Response to Submissions

Cooloo Wind Farm (ACP
Ref. 323761)

Document Title: **Response to Submissions**

Drawn By	Checked By
EF	RW
Project No. 190723	Drawing No. Figure 6-2
Scale 1:200,000	Date 18/09/2025

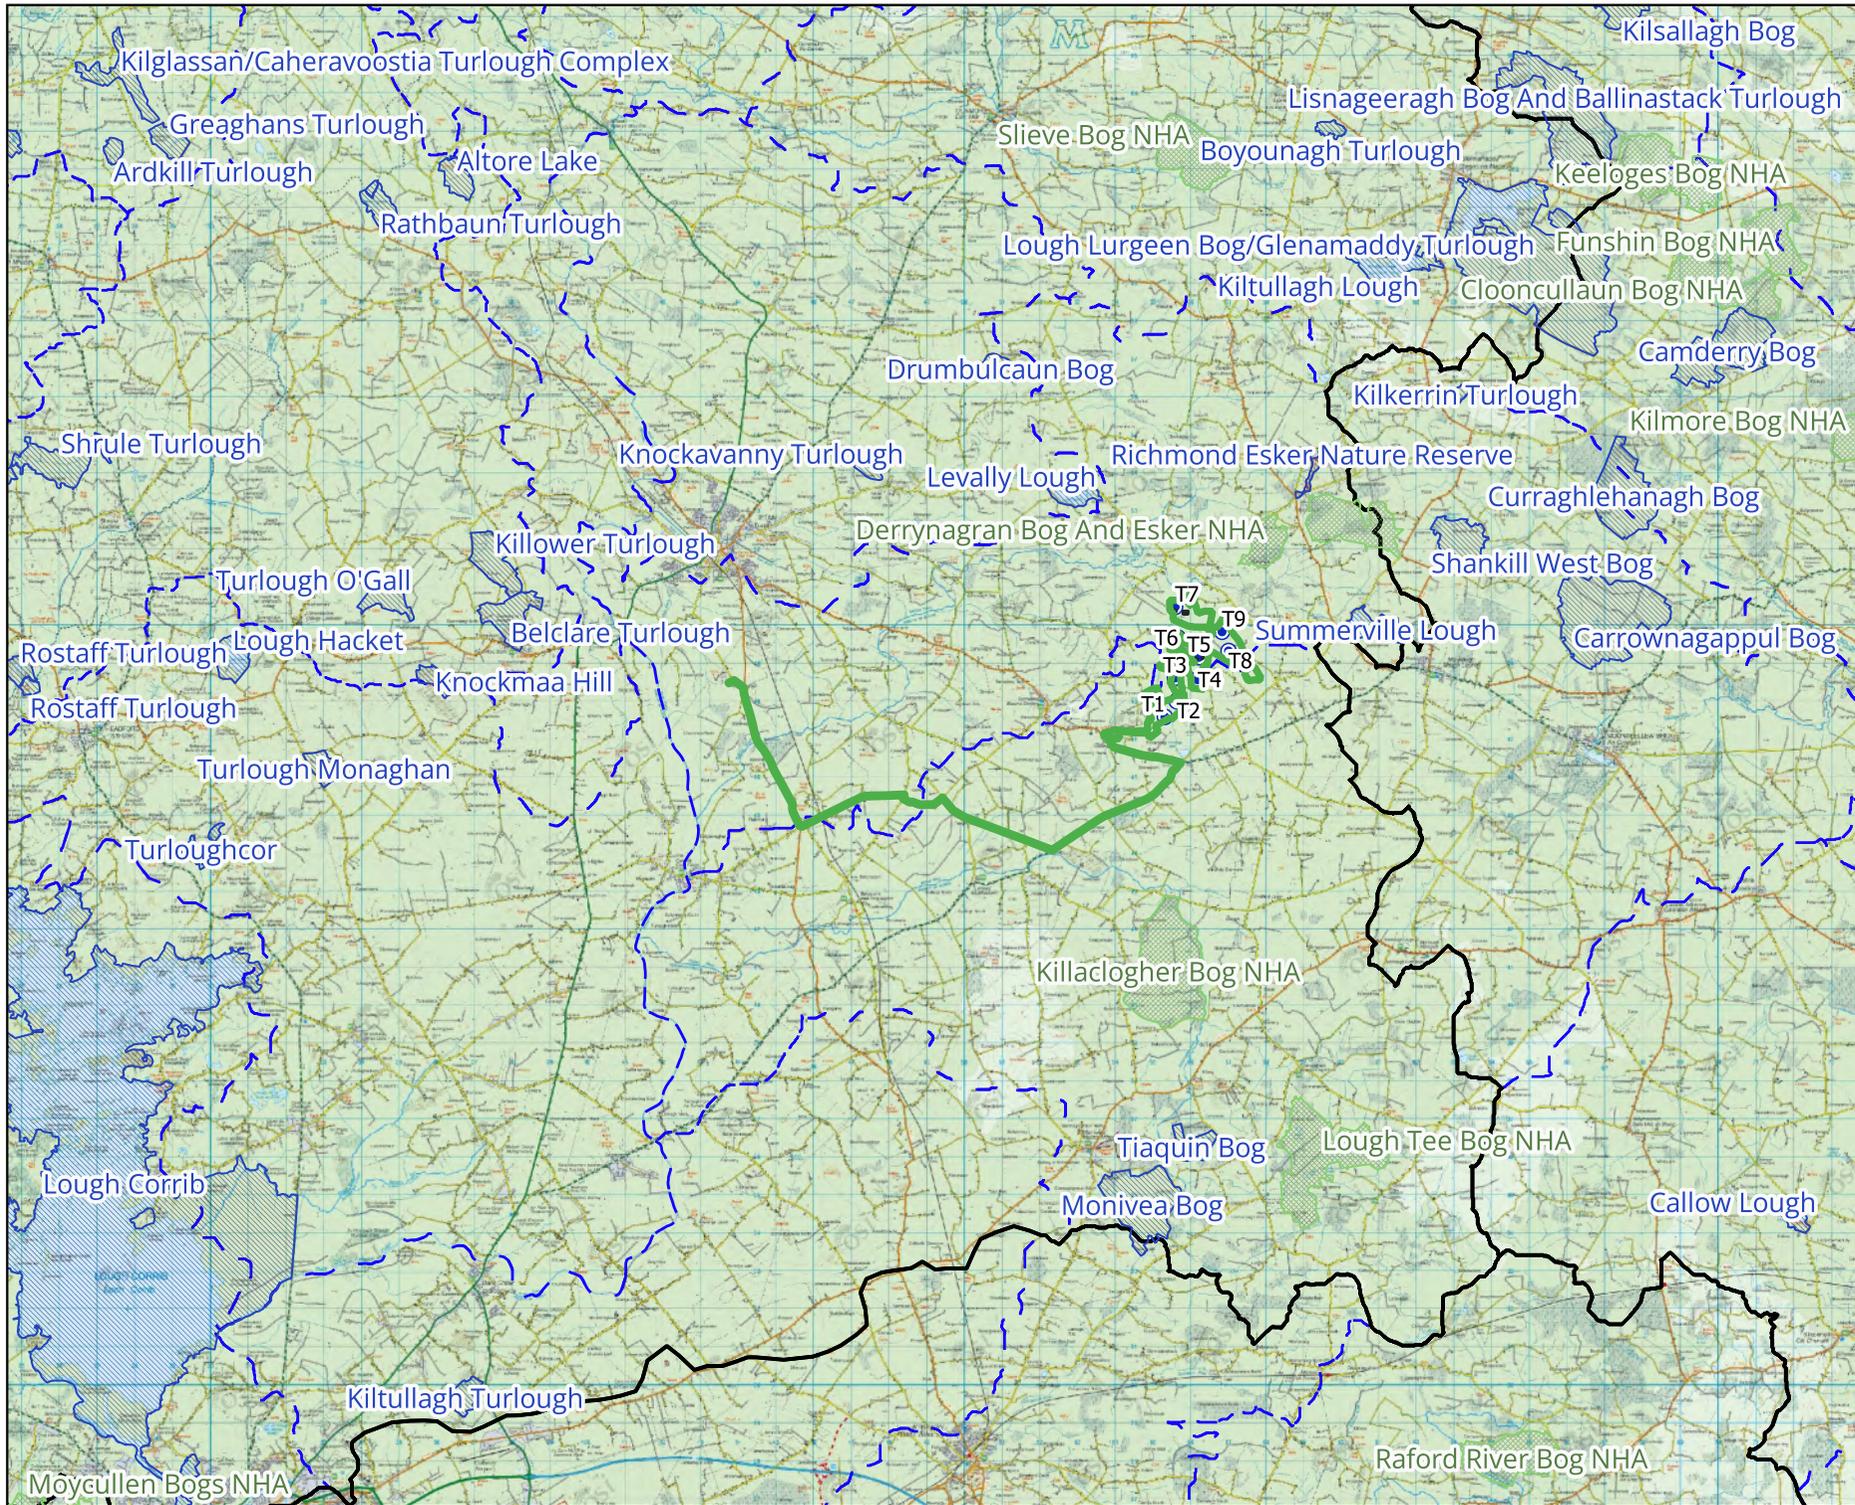
The Natura Impact Statement (NIS) produced for the Proposed Wind Farm has addressed the potential for indirect effects on the Lough Corrib SAC and Lough Corrib SPA. None of the Proposed Wind Farm is located within the SAC boundaries, however the proposed grid connection crosses the SAC at the Grange River (Ballinderry Bridge), an existing watercourse crossing in one location, as detailed in Figure 4-1 of the NIS. Mitigation has been provided for construction phase hydrological impacts in Section 6.2.3, which provides a suite of mitigation to prevent any adverse effects on the SAC and SPA, located downstream of the Proposed Wind Farm. Mitigation has also been provided for the potential effects from the removal of vegetation cover and progressive replacement of natural surface with low permeability surfaces during the operation phase, in Section 6.2.3.1.1 of the NIS.

Figure 6-1 and Figure 6-2 of Chapter 6 of the submitted EIAR is shown below and shows the European designated and nationally designated sites in proximity to the Site. It is noted that these figures are not included in the digital copy of Chapter 6 but are included in in the hard copy of the EIAR, which is publicly available at the offices of both the Commission and GCC. The figures are a visual representation of the information included in Chapter 6, Section 6.3.1.2, of the submitted EIAR and does not present any new or additional information.

Figure 13-1

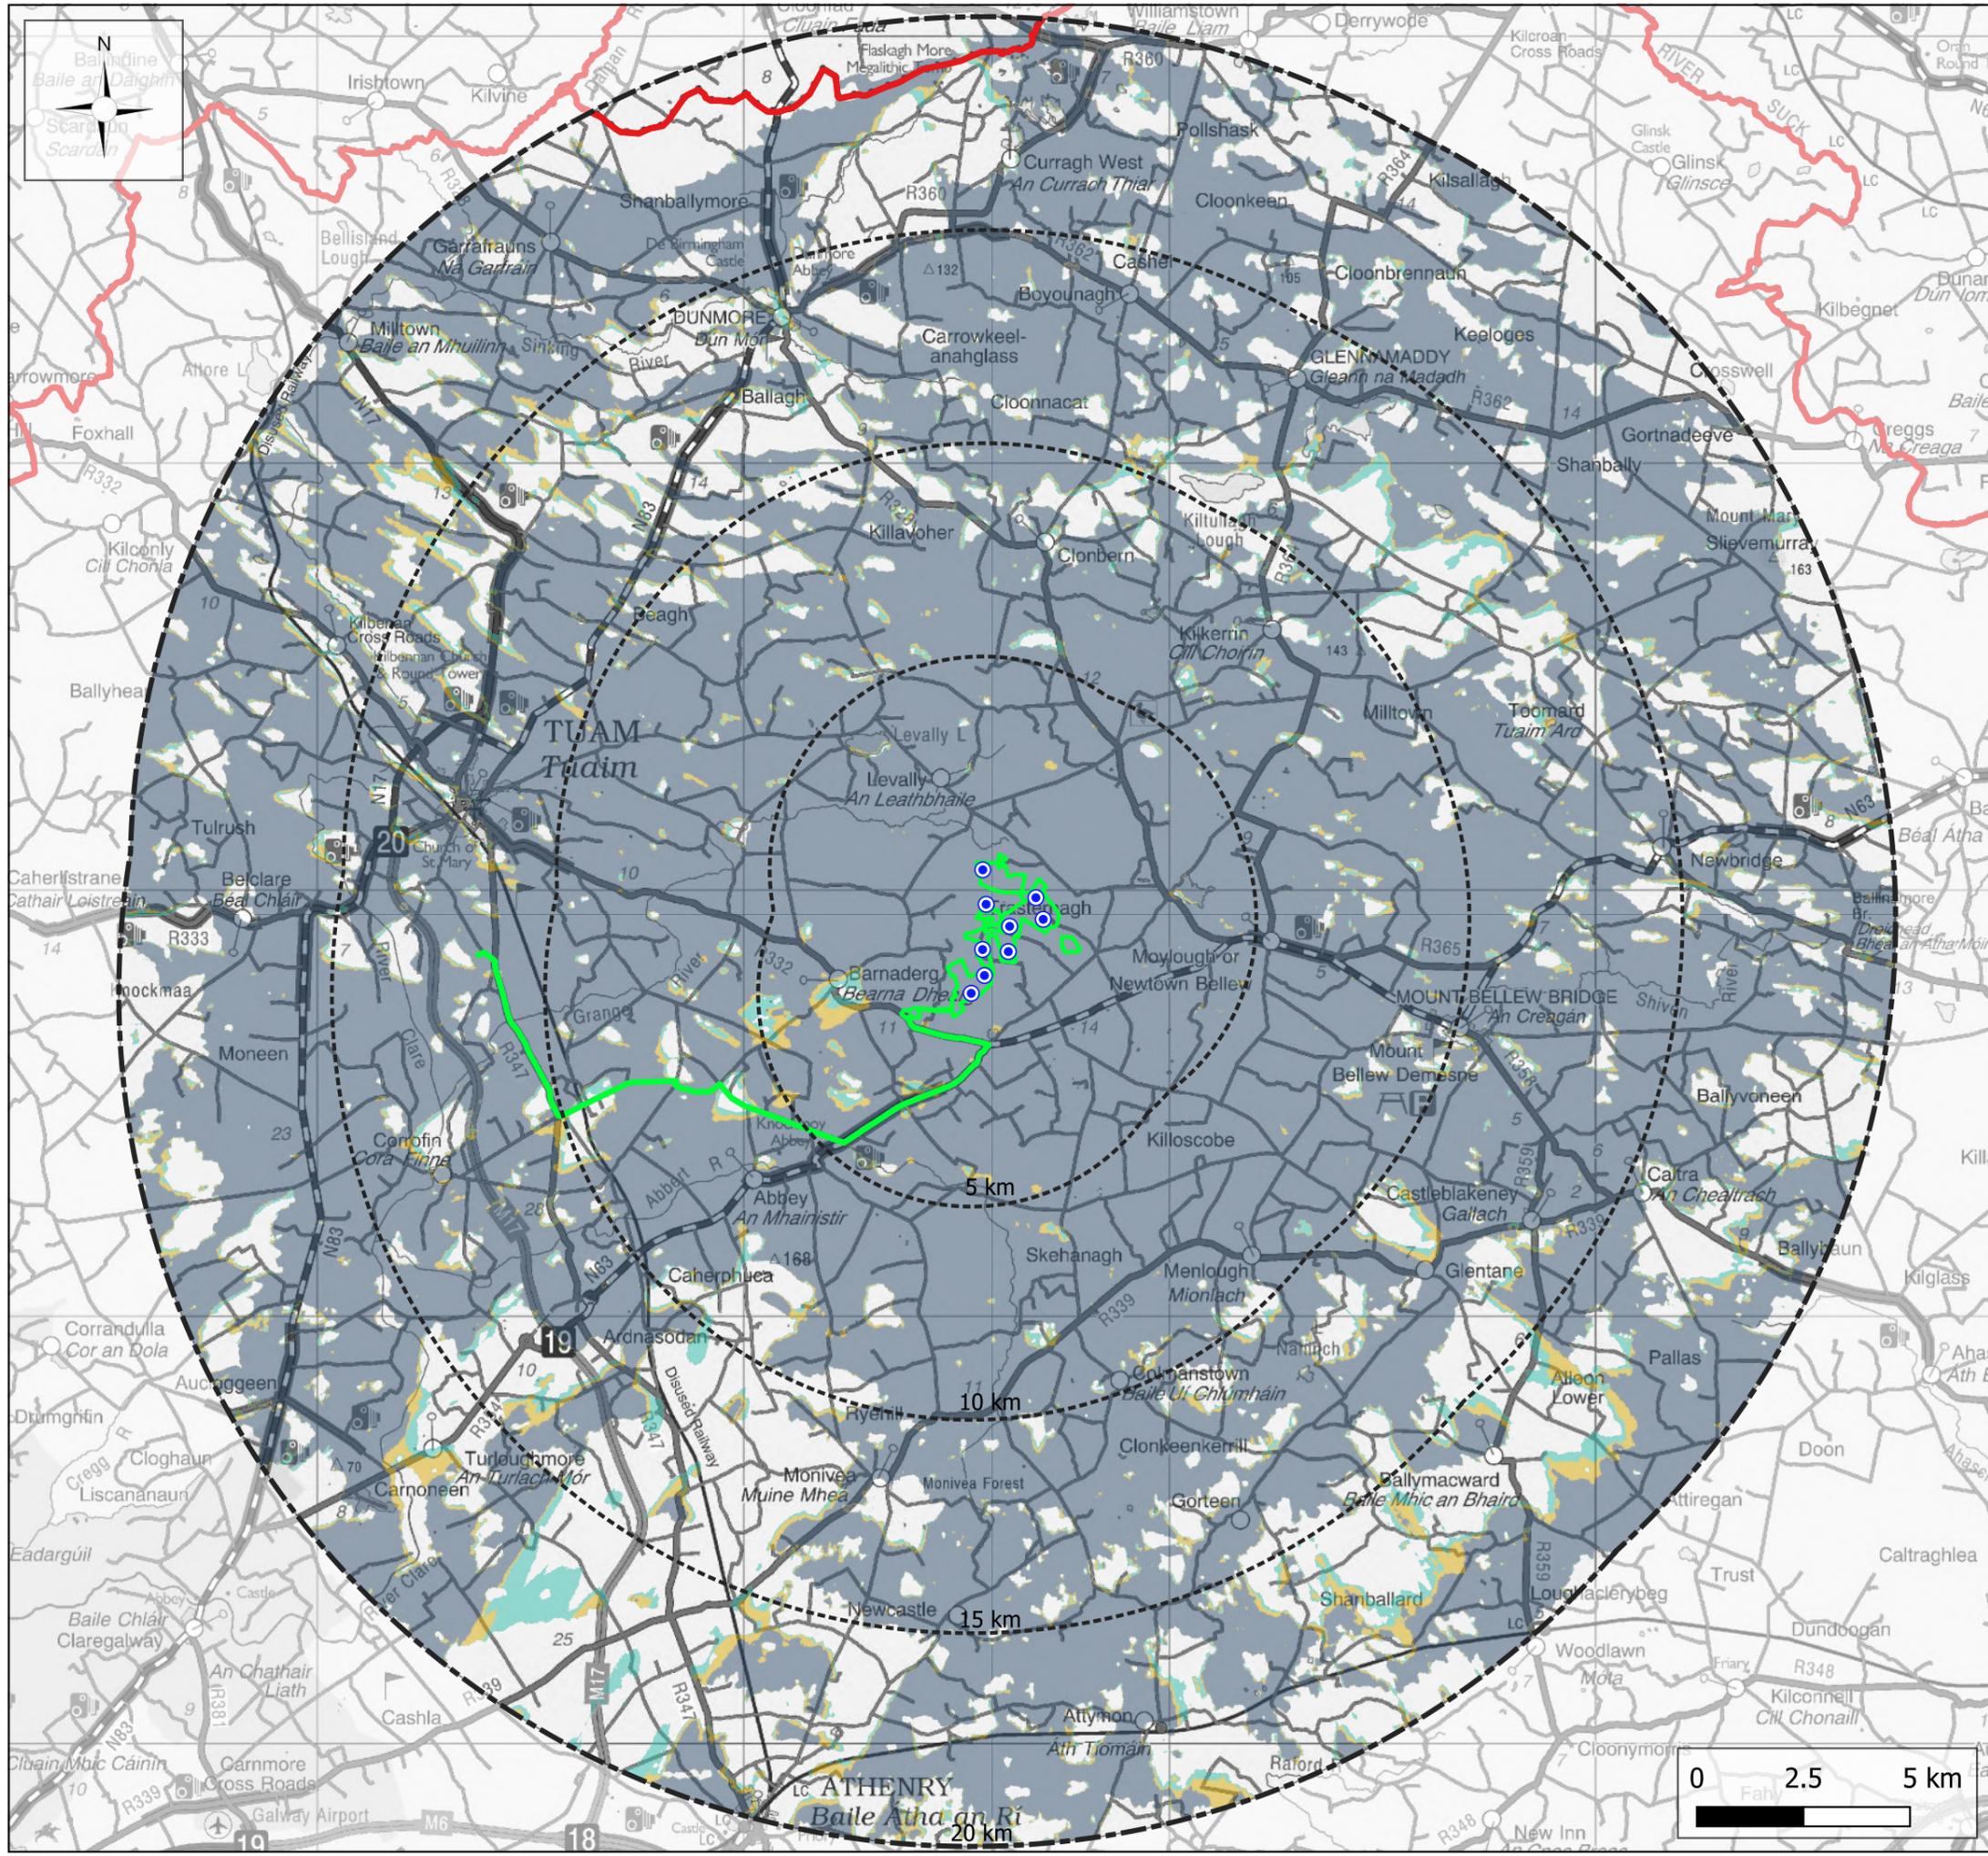
Views from all other key visual receptors were represented in the final selected viewpoint locations. Viewpoints were chosen having regard to the SNH Guidance v.2.2 (2017) which advises that a range of views should be shown at a range of distances, aspects and varying elevations, and that images should illustrate instances where the proposed turbines will be completely visible as well as partially visible. Consideration was also given to ensure that photomontages captured other wind farm developments in the LVIA Study Area in order to assess cumulative landscape and visual effects.

Figures 13-1, 13-9, 13-14 and 13-16 of Chapter 13 of the submitted EIA below show the Zone of Theoretical Visibility (ZTV) (Fig. 13-1), Landscape Character Units and ZTV Map (Fig. 13-9), Visual Baseline Map with ZTV (Fig. 13-14), and the Visual Receptors, Viewpoint Locations and ZTV (Fig. 13-16) in proximity to the Site. The LVIA Baseline Map included as Appendix 13-4 of the submitted EIA is also shown below. It is noted that these figures were subject to issues with the compression of the files and as a result did not show the coloured classification areas concerning the ZTV in the digital copy of Chapter 13. The maps were available in the hard copy of the EIA, which is publicly available at the offices of both the Commission and GCC. The figures are a visual representation of the information included in Chapter 13, Sections 13.3.2, 13.4.1.1.5, 13.5, and 13.7.3.2.1 and Appendix 13-4 of the submitted EIA and does not present any new or additional information.
